Subject: ***Responses to Appeals – Los Angeles City Planning Commission
Ivar Gardens Hotel Project, 6409 Sunset Blvd., Los Angeles, California***

Attachment A—Annotated Revised Figure 7-2 (“Net New Project Traffic Volumes”)

Annotated Revised Figure 7-2 Net New Project Traffic Volumes – Weekday PM Peak Hour

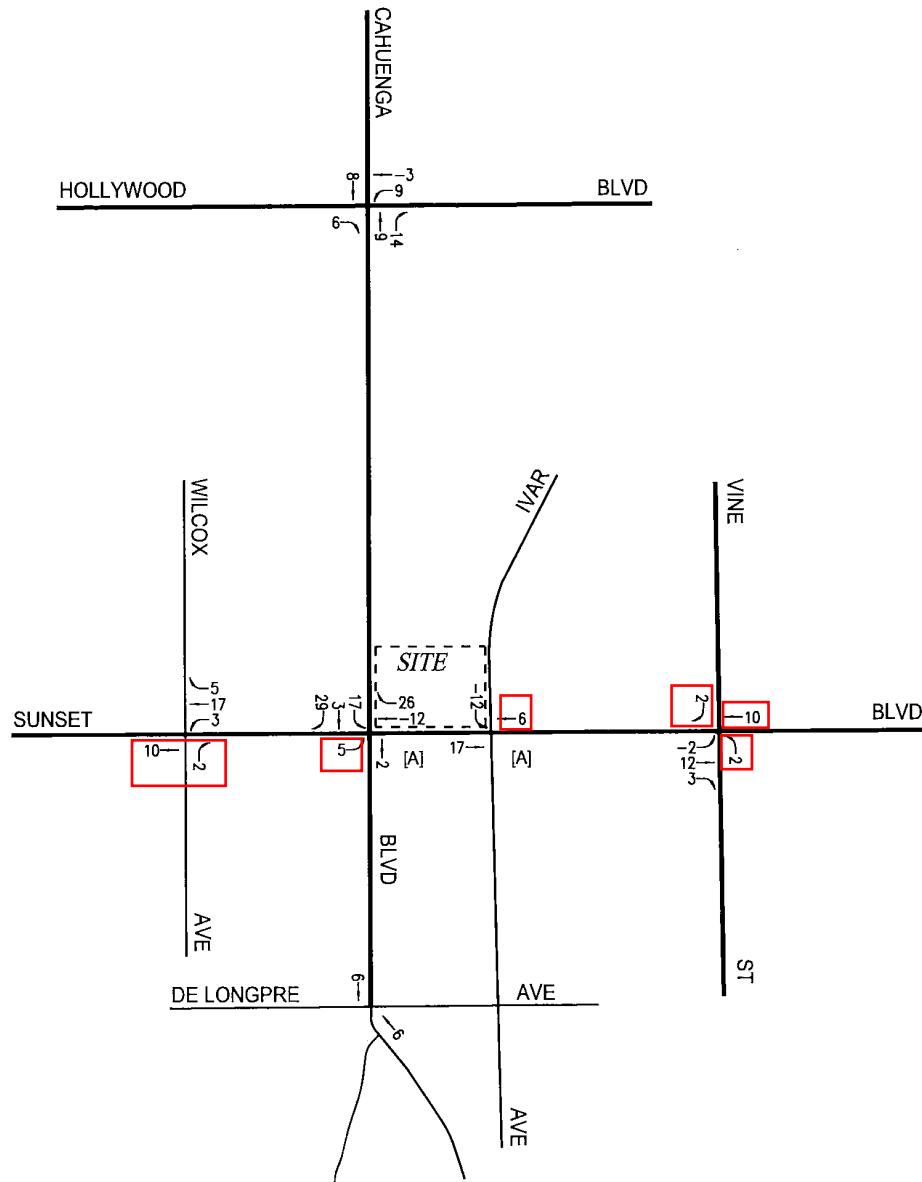
This point is illustrated by examining the revised Figure 7-2 provided in Attachment 2 to the April 2017 Response to Appeals document, and presented here as Attachment A. (Reference: Memorandum from Clare M. Look-Jaeger, Linscott, Law & Greenspan, to Jordann Turner, Department of City Planning, “Response to Public Comments – Ivar Gardens Hotel Project Traffic Impact Study,” September 26, 2016.) As shown on that figure, a total of 12 “net new” trips are shown to be exiting the Sunset Boulevard/Wilcox Avenue intersection and heading eastbound toward the project site (10 eastbound through vehicles and 2 northbound right turns). However, on the eastbound approach at Sunset Boulevard/Cahuenga Boulevard, only 5 new trips are shown. Where did the other 5 trips go? It is simply illogical to suggest that the volume of project-related traffic is lower adjacent to the project site than it is farther from the site.

A similar illogical situation is shown for westbound traffic approaching the site. From Sunset Boulevard/Vine Street, 14 westbound vehicles approach the project site (2 southbound right turns, 10 westbound throughs, and 2 northbound left turns). At Sunset Boulevard/Ivar Avenue, however, only 6 westbound vehicles are shown, representing an apparent loss of 8 project-generated vehicles.

These discrepancies can be traced directly to the improper treatment of pass-by trips for both the existing land use and the proposed project. Specifically, they are the result of the failure to apply the generally-accepted pass-by trip adjustment procedure, as documented in the Institute of Transportation Engineers (ITE) *Trip Generation Handbook* (Third Edition, August 2014, pp. 91 - 98). As we pointed out in our September 1 letter, the *Trip Generation Handbook* presents a

The examples we cited above concerning the apparent loss of eastbound and westbound traffic approaching the proposed project site confirm that the traffic assignment documented in the LLG study is erroneous. We continue to believe that the study needs to be revised to employ the standard approach to assigning primary, pass-by, and diverted trips for the proposed project. Moreover, we believe that there is a reasonable likelihood that correcting the analysis will result in a previously-unreported significant traffic impact at the intersection of Sunset Boulevard/ Cahuenga Boulevard.

Fast-Food Restaurant with Drive-Through Window PM Peak Hour Trip Generation Rate Summary Page

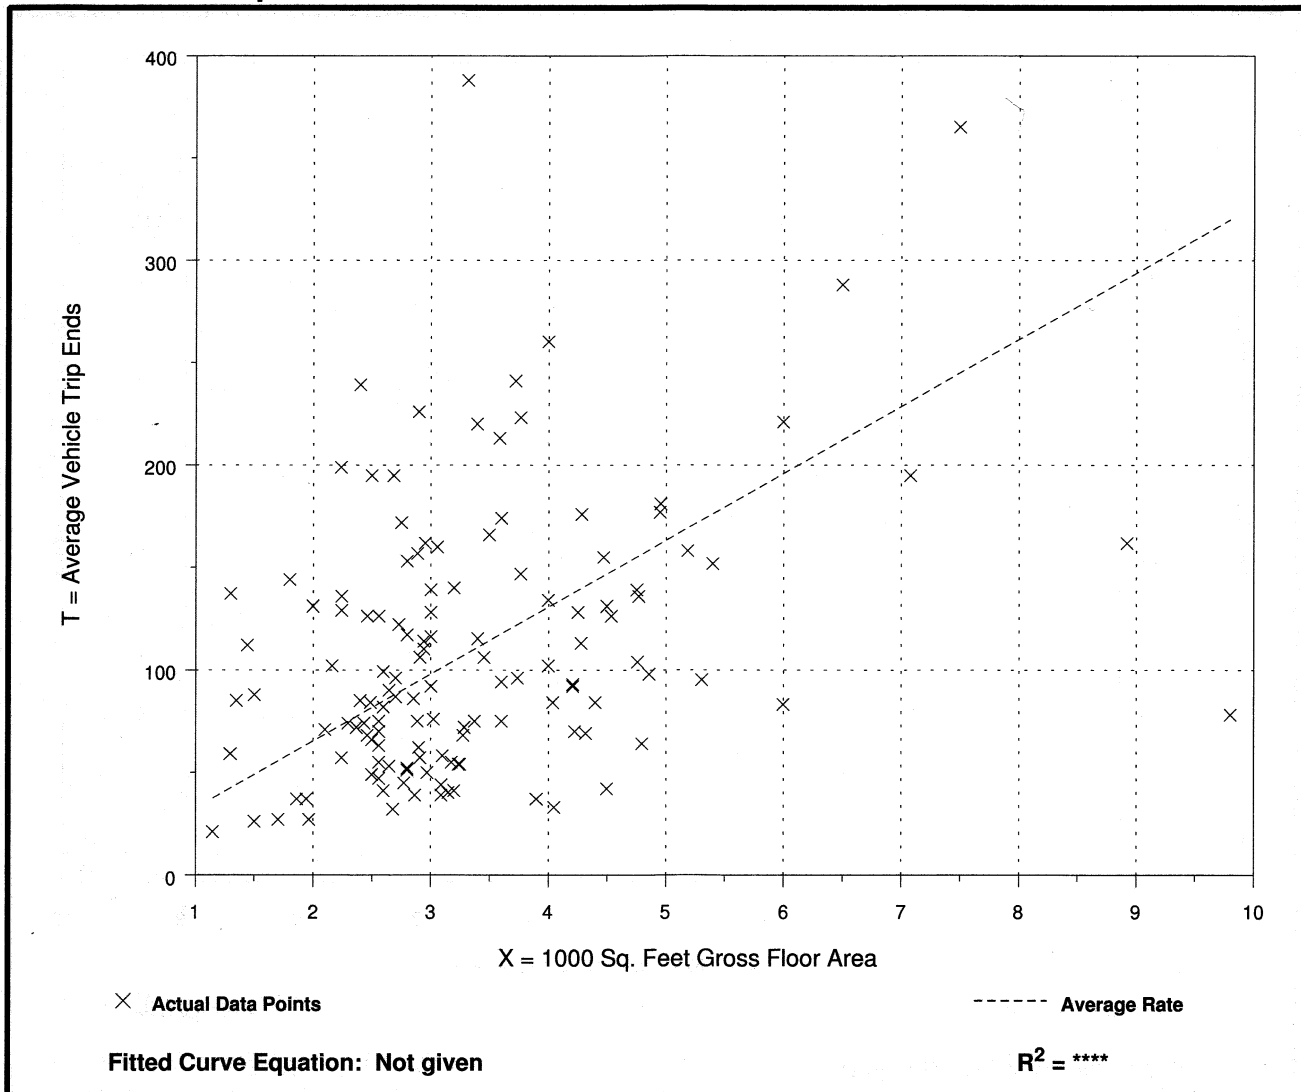
We note, for example, that the estimated number of PM peak-hours trips associated with the existing restaurant was based on the standard, average ITE rate of 32.65 trips per 1,000 square feet (SF). However, we also note that among the 132 locations studied in developing this average rate, the individual trip rates range from 7.96 trips per 1,000 SF to 117.15 trips per 1,000 SF. Attachment B contains a copy of the pertinent page from the ITE document. (Reference: Institute of Transportation Engineers, *Trip Generation*, Ninth Edition, 2012, p. 1914.) Obviously, tremendous variation exists from one location to the next within this land use. Given its location within the popular Hollywood area, it would not be surprising to find that the subject location might have higher levels of pedestrian activity and correspondingly lower levels of automobile activity than other similar restaurants. If that is the case, the restaurant’s peak-hour traffic volumes would be over-estimated by the standard ITE rates; this would lead, in turn, to underestimation of the number of “net new trips” associated with the proposed project.

Aerial View – Sunset Boulevard/Cahuenga Boulevard

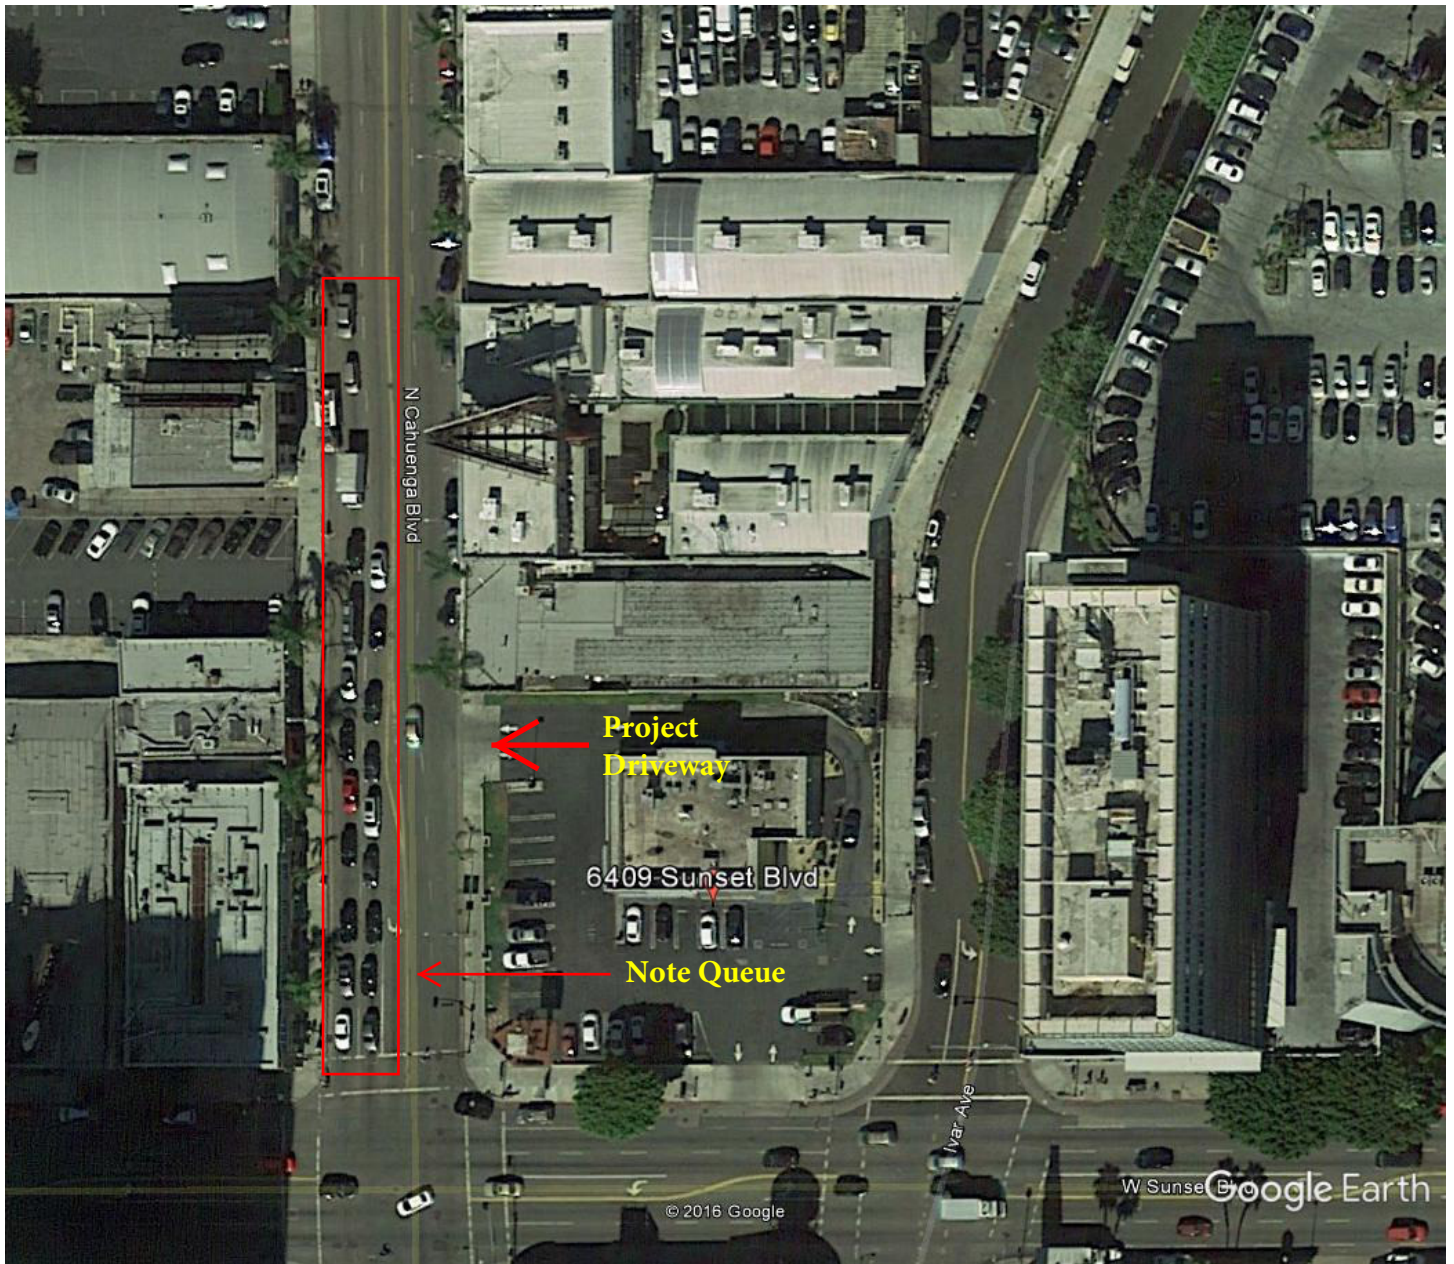
→ None of the referenced responses address the question raised in the comment. The importance of the comment is illustrated in Attachment C, which presents a recent Google Earth aerial view showing the existing queue of vehicles on southbound Cahuenga Boulevard at Sunset Boulevard extending well past the proposed driveway location. Clearly, a driver attempting to turn left out of the project site will find it almost impossible to do so under the conditions shown here, and a truck driver that attempts to barge into the southbound queue will block the flow of northbound traffic on Cahuenga Boulevard.
